To: T10 Technical Committee
From: John Worden (john.worden@seagate.com)
Date: 28 October 2002
Subject: 02-424r2 SAS Additional Port Layer Tweaks

This revision adds clarification and minor corrections to the SAS Port layer rewrite (02-393r1), [corrects the header in revision 0, and adds changes discussed in the 10/24/02 SAS Protocol Meeting in Las Vegas, NV.](#) Changes include:

Figure 2. Port layer Overall Control (PL_OC) state machine

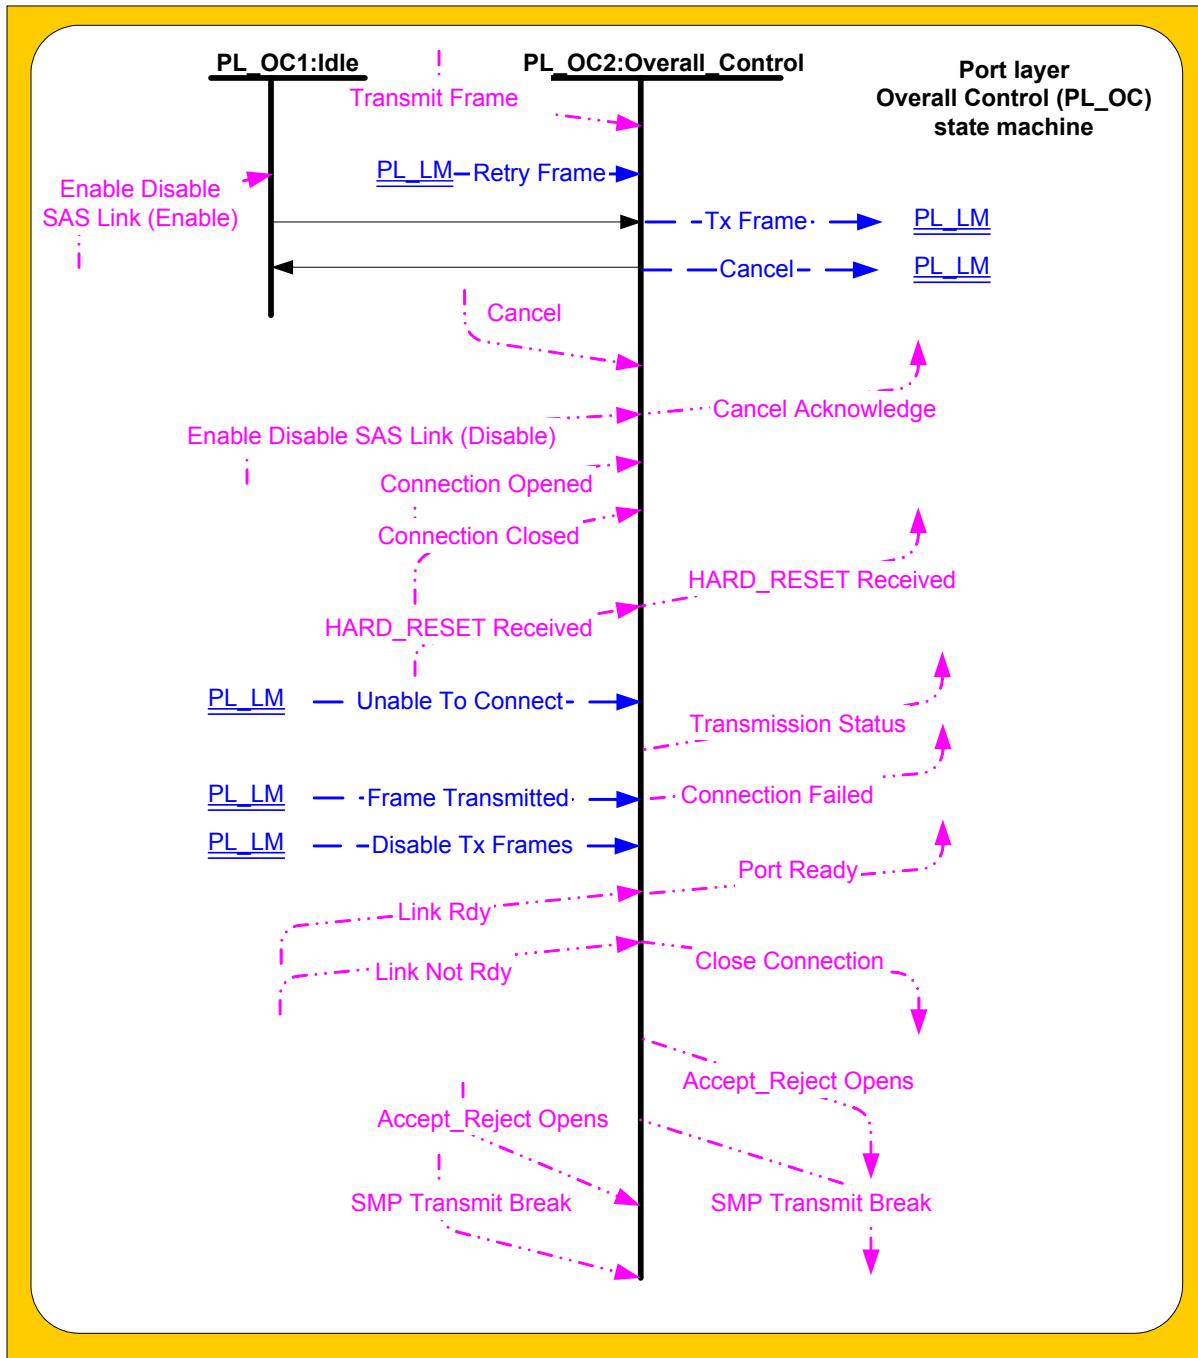
(Editors Note: Delete "Link Rdy" and "Link Not Rdy" from figure 2 ???)

Figure 3. Port layer Link Manager (PL_LM) state machine – part 1

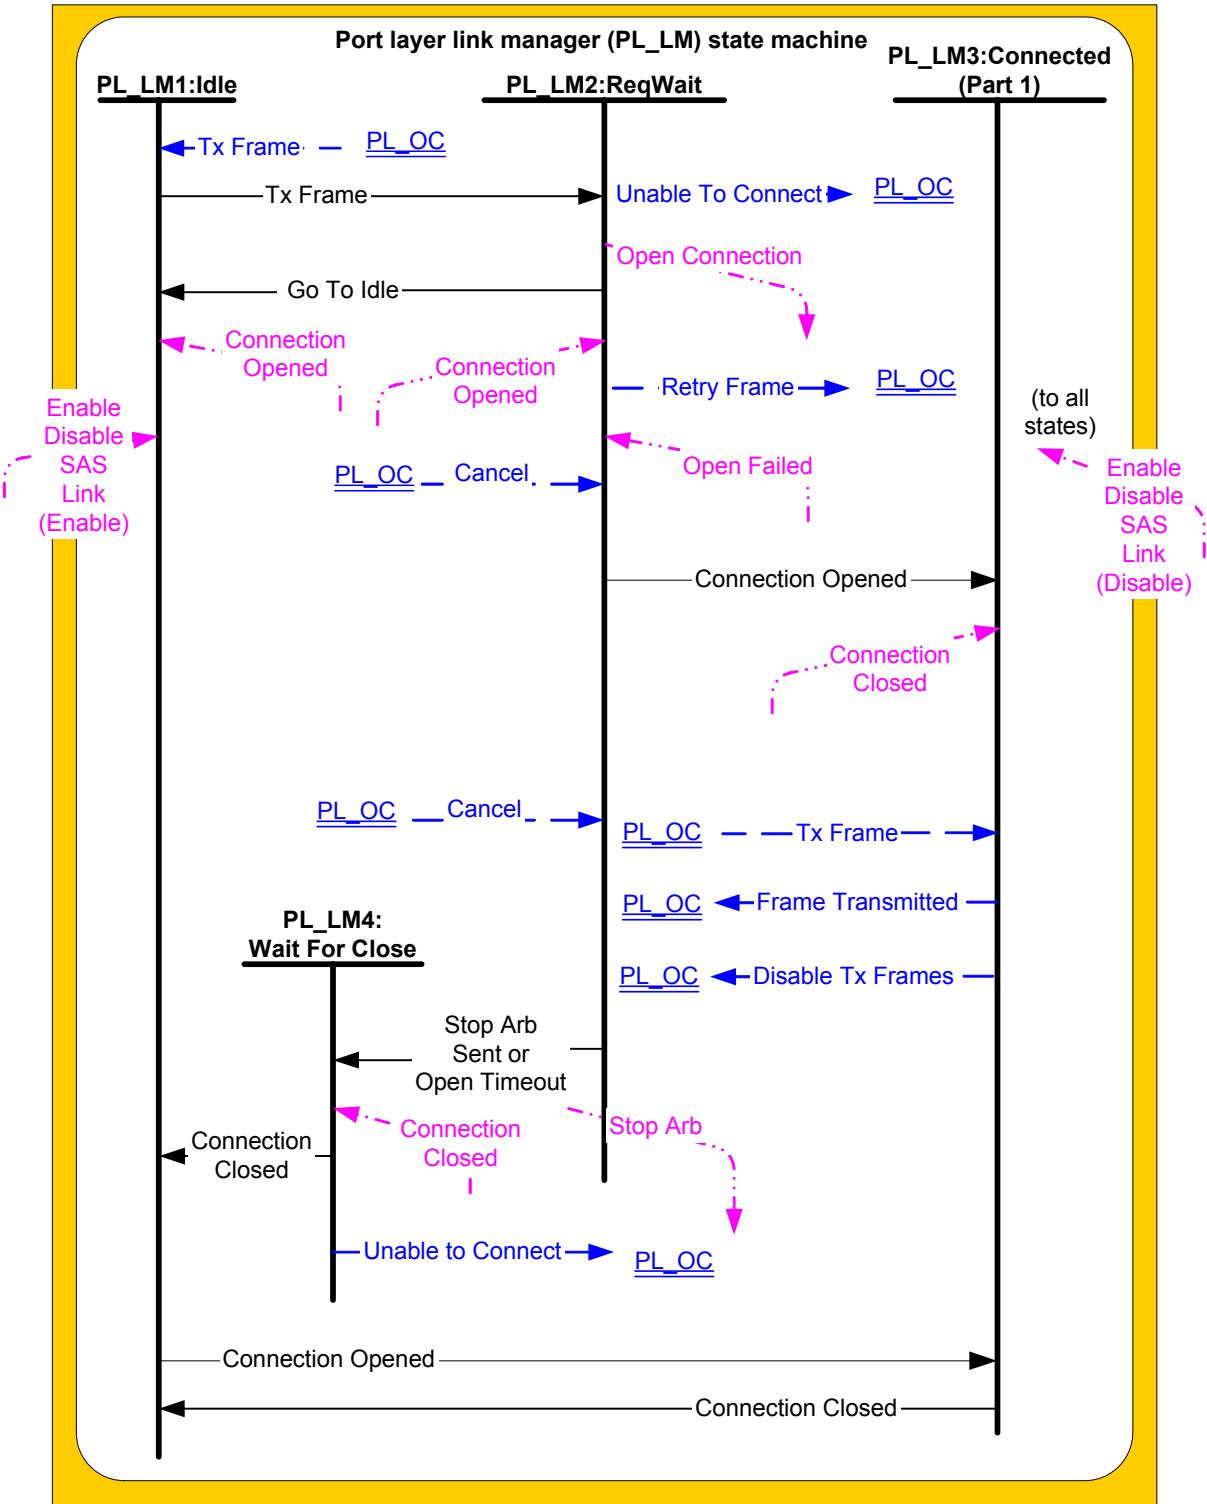
- a) Clarifies usage of the I_T nexus loss timer
- b) Adds the I_T nexus loss argument to the Transmit Frame request
- c) Adds Figure 3. Transmit Arguments plus explanatory text
- d) Minor technical corrections and other clarifications
